PLANNING, ZONING, & BUILDING DEPARTMENT
PZ&B Staff Combination Memorandum: Architectural Commission and Town Council

SUBJECT: ARC-24-004 (ZON-24-014) 334 CHILEAN AVE (COMBO)

MEETING: JANUARY 24, 2024 ARCOM
FEBRUARY 14, 2024 TC

Site Plan. Highlighted areas indicate areas of variance request.

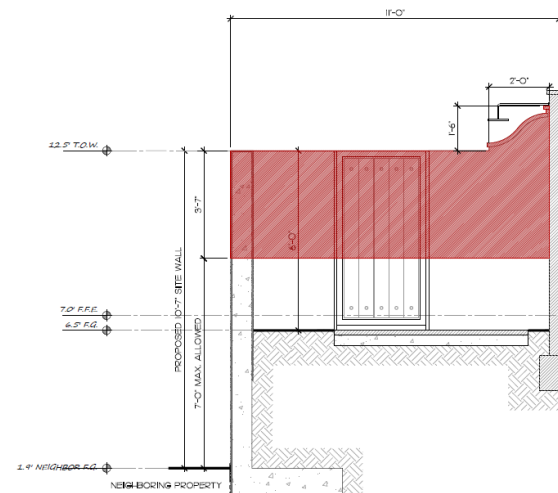
A preliminary review of the project indicates that the application, as proposed, is inconsistent with the Town zoning code and requires four (4) variances for modifications to the previously approved hardscape and landscape plan.

New opaque cypress wood vehicular and pedestrian gates are proposed on Chilean Avenue with a new refuse bin area. Changes for equipment yard areas are also proposed, with variances required for pool heater setback, and variances required to exceed maximum screening wall height. The original application was approved prior to the Town of Palm Beach adopted an ordinance limiting the amount of fill permitted to be added on a given site, allowing this applicant to make plan modifications under the previously approved code condition. The equipment locations are roughly the same as the previous approval, however, staff hypothesizes that the variances required to screen the equipment were not known or completely realized by the applicant at the time of the original application approval.

West side yard variance diagram

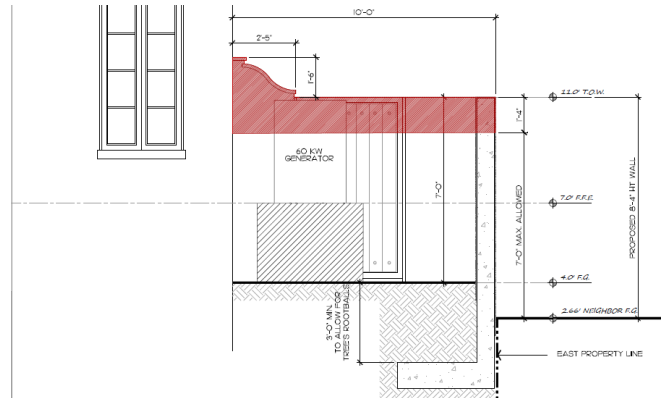
Variance number 1 is for the construction of a site wall in the west side yard with a height of 10' – 7" from lowest grade, in lieu of the 7' maximum wall height permitted.

East side yard variance diagram.

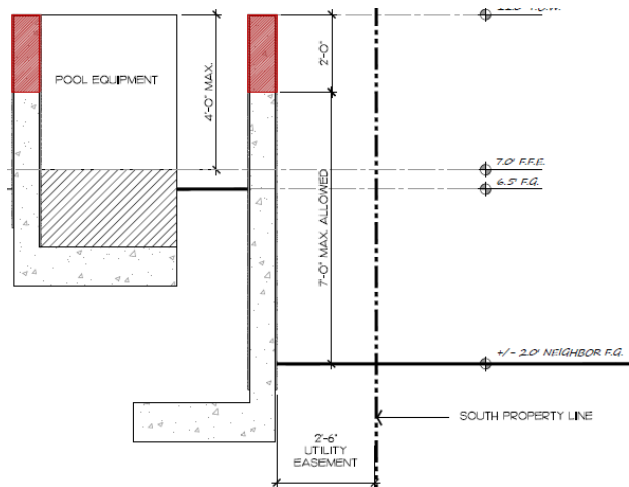
Variance number 2 is for construction of a site wall in the east side yard that is 8' – 4" in height in lieu of the 7 ft maximum height permitted. This wall height is required to adequately screen the generator installed at minimum FEMA elevation from the property to the east.

South rear yard variance diagram.

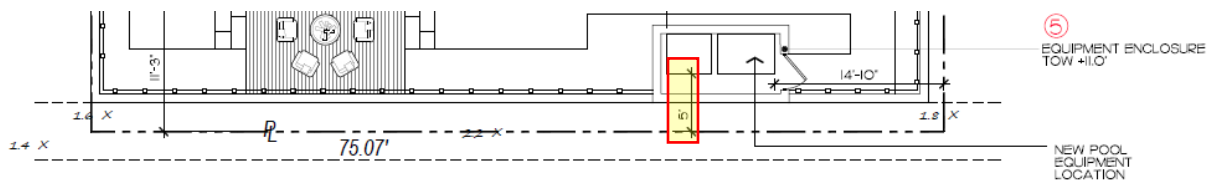
Variance number 3 is for construction of a site wall in the south rear yard with a height of 9' in lieu of the 7' maximum permitted. The increased wall height is required to screen the pool equipment located in this area.
